**PLANNING BOARD RESOLUTION
VILLAGE OF MOUNT KISCO**

**NEGATIVE DECLARATON OF SIGNIFICANCE
PRELIMINARY AND FINAL SUBDIVISION APPROVAL**

**1 Leonard Street and 2 ½ Leonard Street
Burgler/Smoller Subdivision
Cal # PB2021-0409
January 24, 2023**

1 SITE DEMOLITION PLAN
1"=10'-0"

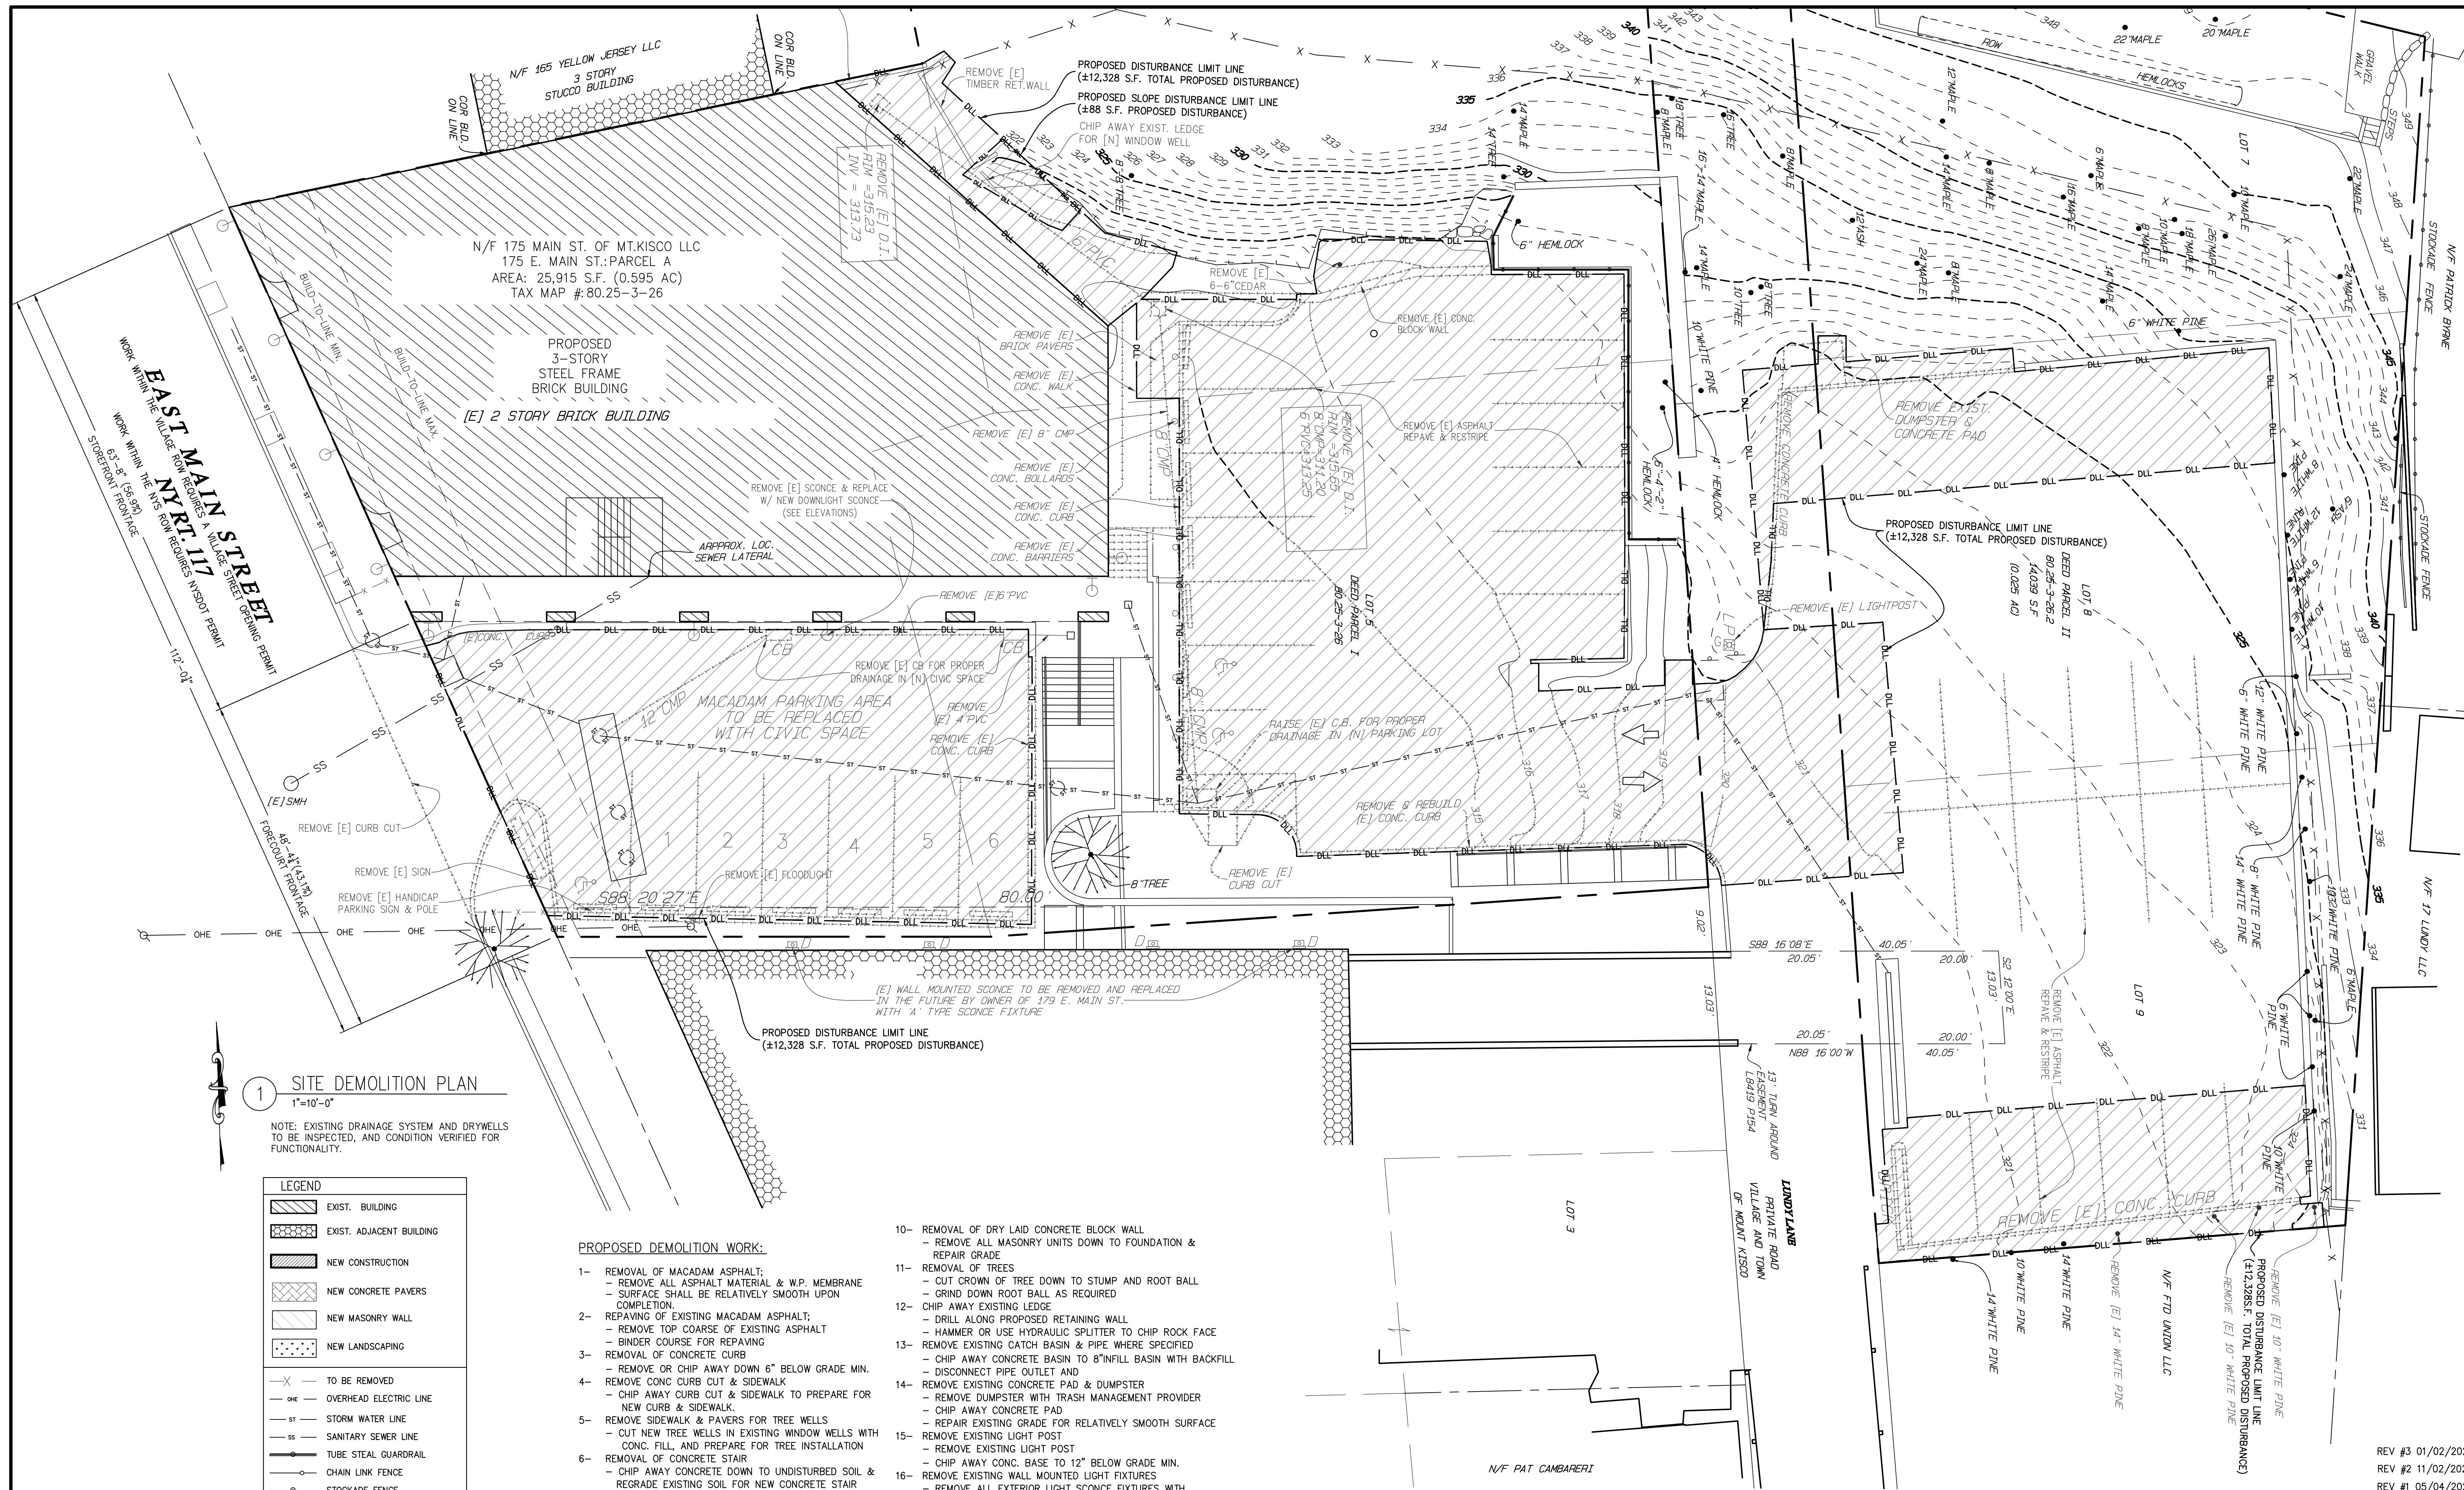
7. Disturbance areas have been revised to include any removal of asphalt to subgrade or other ground disturbances. The total proposed disturbance is 12,328 S.F. and has been noted on sheet S1

18. The existing utility pole flood light has been called out to be removed on Sheet S1.
19. Specifications/Manufacturer information for pavers has been provided on sheet S7 & S8 and shall be coordinated with the town.

1 PROPOSED SITE PLAN
1"=10'-0"

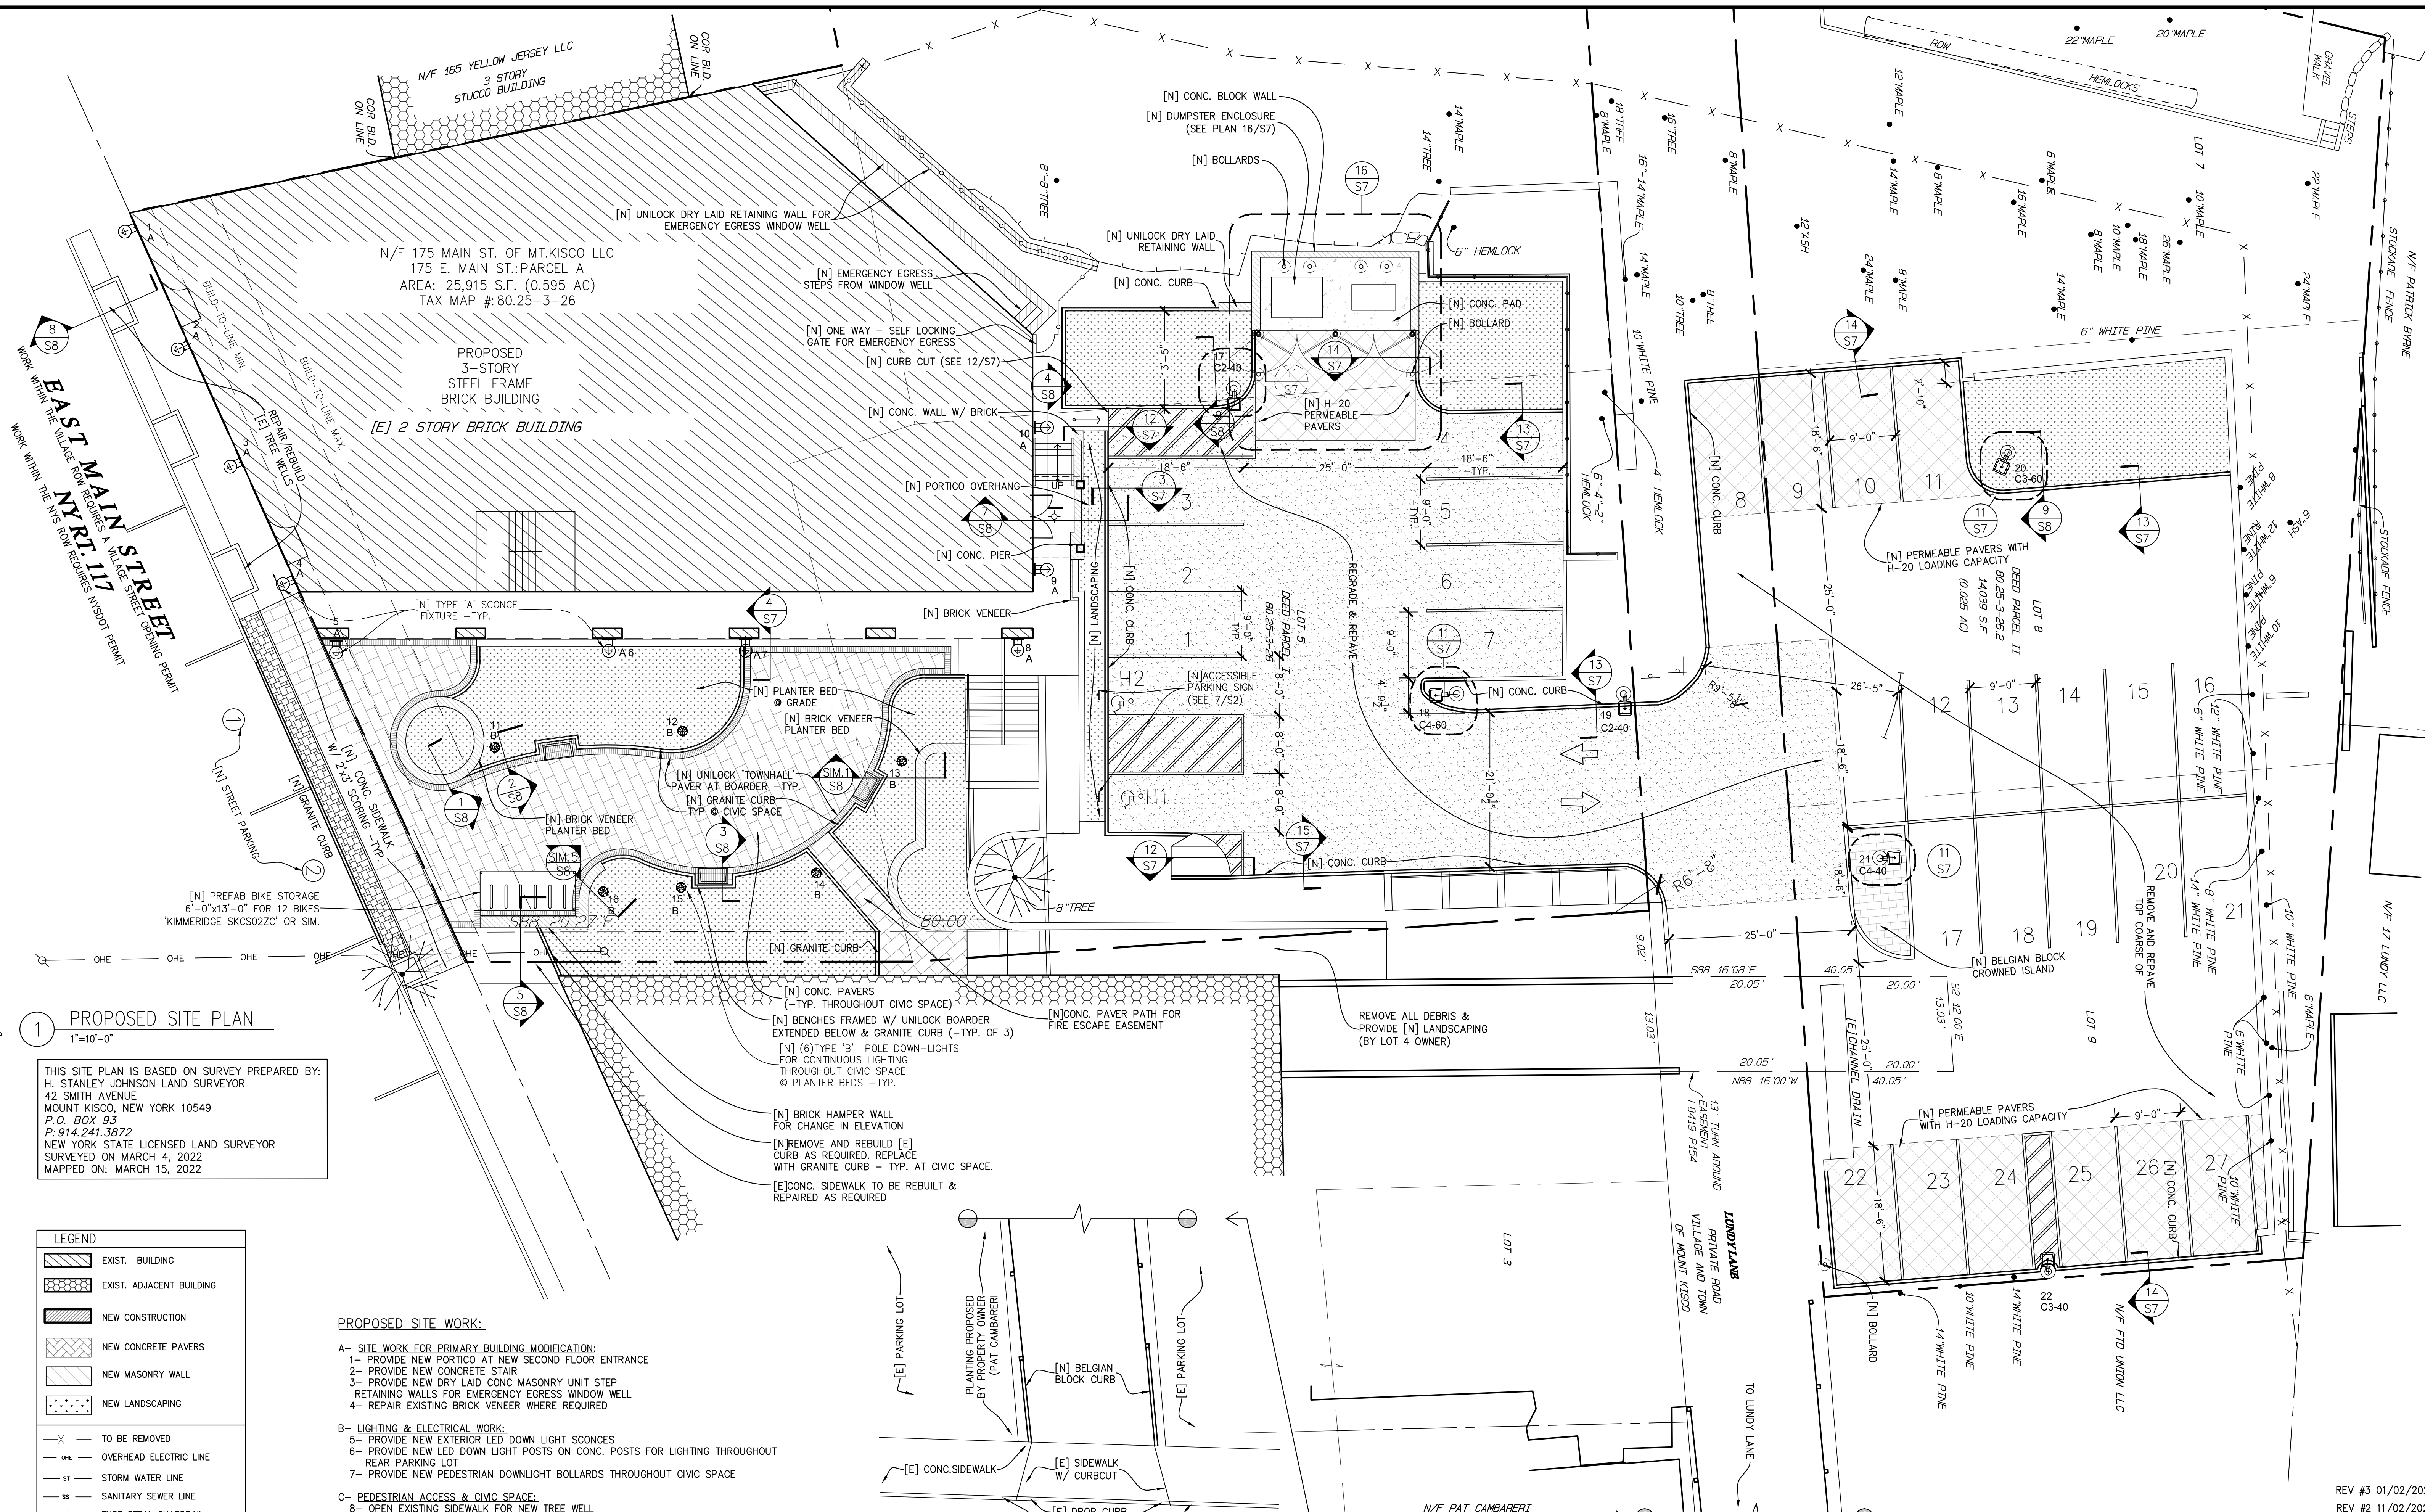
8. Parking space width dimensions have been provided in rear lot; all spaces are 9’-0” see parking layout on sheet S2.
9. Van accessible aisle for new parking layout has been called out at 8’-0”. Please see sheet S2 For handicap parking dimensions, see sheet S4 for elevation points and cross slope percentages.

1 PROPOSED LANDSCAPING PLAN
1"=10'-0"

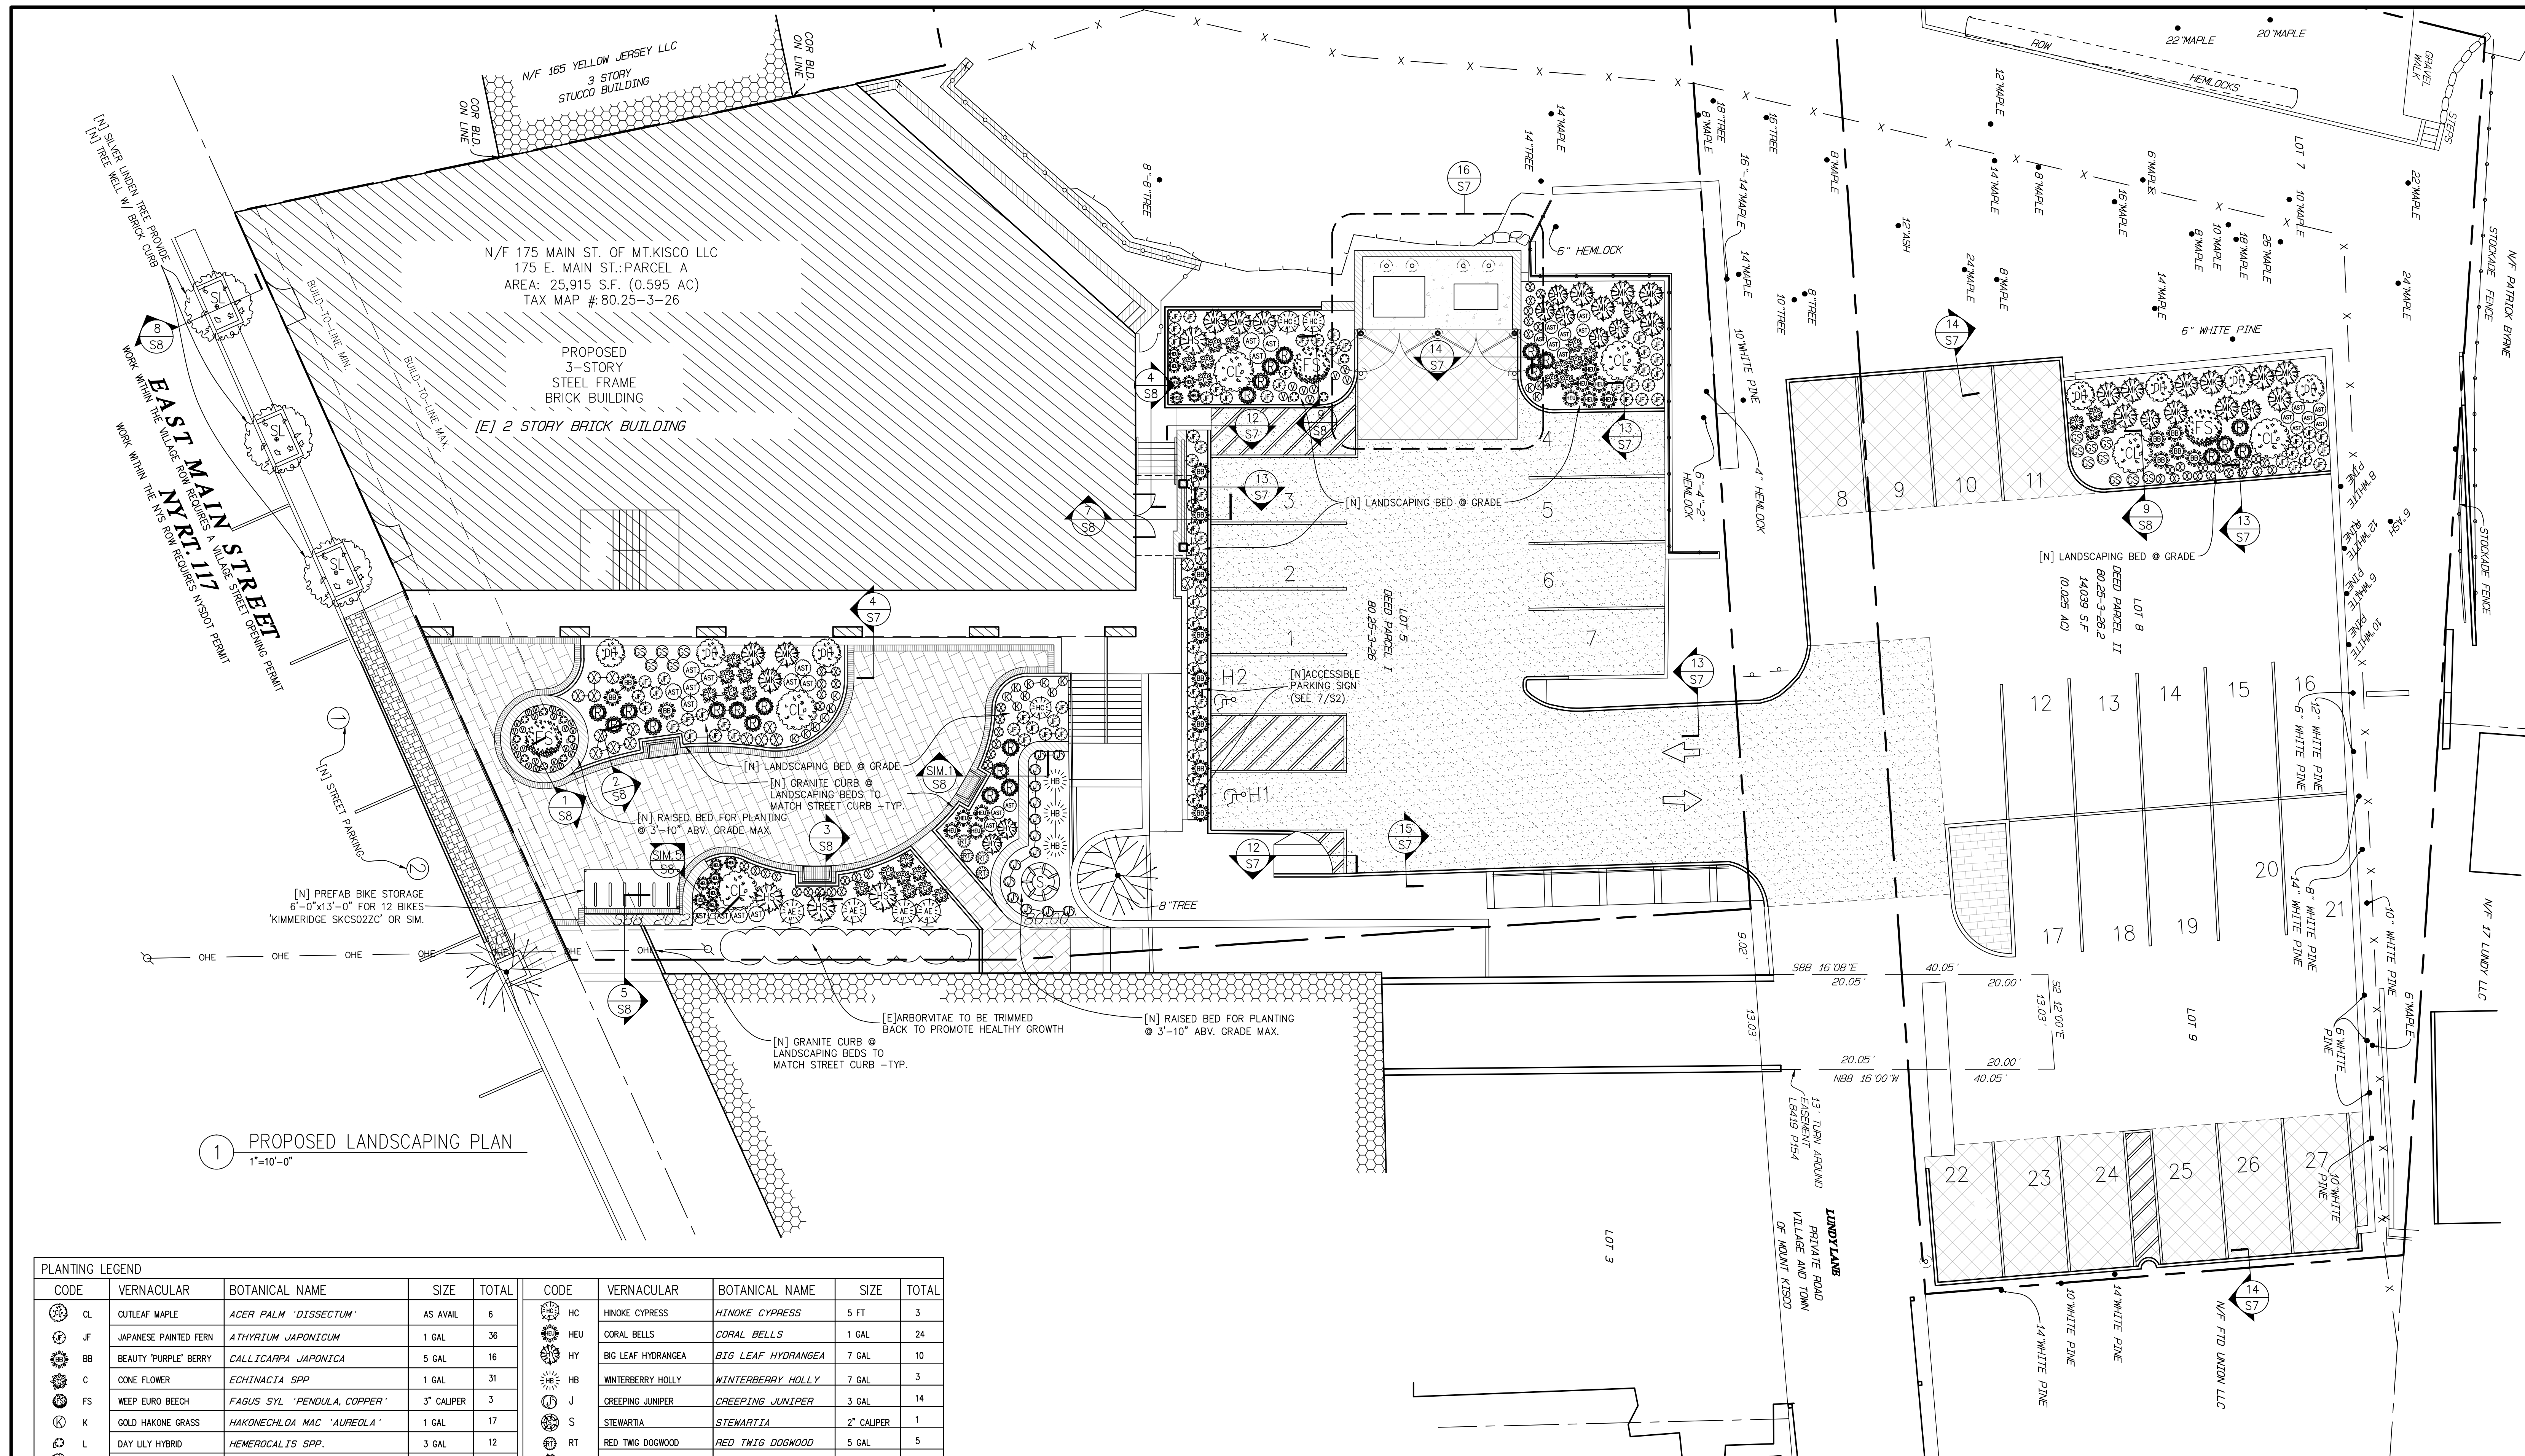
11. The proposed island adjacent to parking space 17 is proposed to be crown Belgian block. A photo has been provided for reference.
12. Typical planting details have been provided and street trees wells have been coordinated with the Village's standards, please see sheet S8. Additionally, all street trees have been called out to be 3" caliper silver linden trees, please see sheet S3.
